UNITED STATES
DEPARTMENT OF THE INTERIOR
BUREAU OF LAND MANAGEMENTFORM APPROVED
OMB NO. 1004-0137
Expires: January 31, 2018**SUNDRY NOTICES AND REPORTS ON WELLS**
*Do not use this form for proposals to drill or to re-enter an abandoned well. Use form 3160-3 (APD) for such proposals.*BUREAU OF LAND CONSERVATION
ARIZONA DISTRICT
MAR 05 2018
RECEIVED**SUBMIT IN TRIPLICATE - Other instructions on page 2**

Well Name: H B 11 FEDERAL 6	Field: PIERCE CROSSING EAST
Location: 1650' FNL & 1980' FWL; SEC 11-T24S-R29E	County: EDDY State: NM
Elevation: 3068' KB; 3051' GL; 17' KB-GL	Spud Date: 5/14/97 Compl Date: 8/28/97
API#: 30-015-29585 Prepared by: Ronnie Slack	Date: 2/1/18 Rev:

PROPOSED PLUG & ABANDONMENT

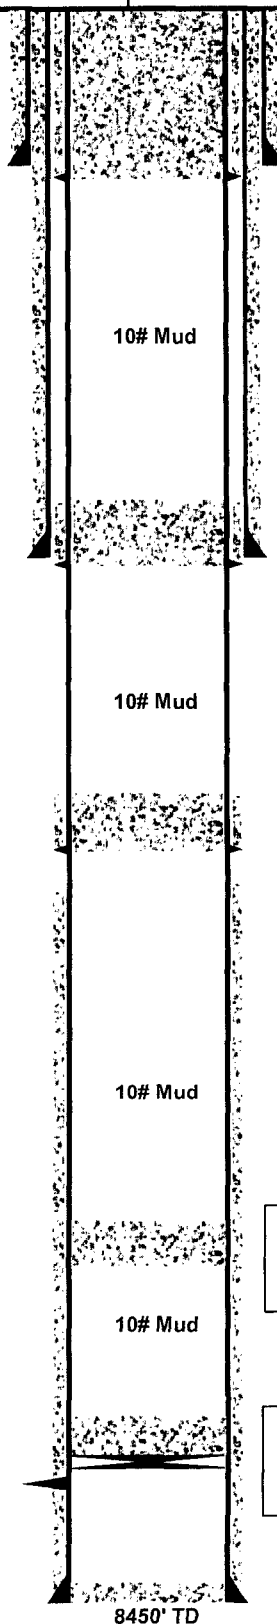
**** BLM REVISED ** BLM REVISED ** BLM REVISED ** BLM REVISED ** BLM REVISED ****

Proposed:
 3. Cut wellhead off 3' BGL. Set dry hole marker.
 2. Pmp 170 sx CI C in/out to surface.
 1. Perf @ 725'.
 (T.Salt 672'; Shoe 355')

Proposed:
 2. Pmp 80 sx (340') CI C in/out @ 3,255' - 2,915'. Tag.
 1. Perf @ 3,255'.
 (Delaware 3153'; B.Salt 3153'; shoe 2974')

Proposed:
 2. Pmp 40 sx (170') CI C in/out @ 3,660' - 3,490'. Tag.
 1. Perf @ 3,660'.
 (3000' spacer)

Proposed:
 1. Spot 25 sx (250') CI C @ 6,910' - 6,660'.
 (Bone Spring 6856')

Proposed:
 2. Spot 25 sx (200') CI H @ 8,030' - 7,830'.
 1. Set CIBP @ 8,030'. Tag. Circ 10# salt gel mud.
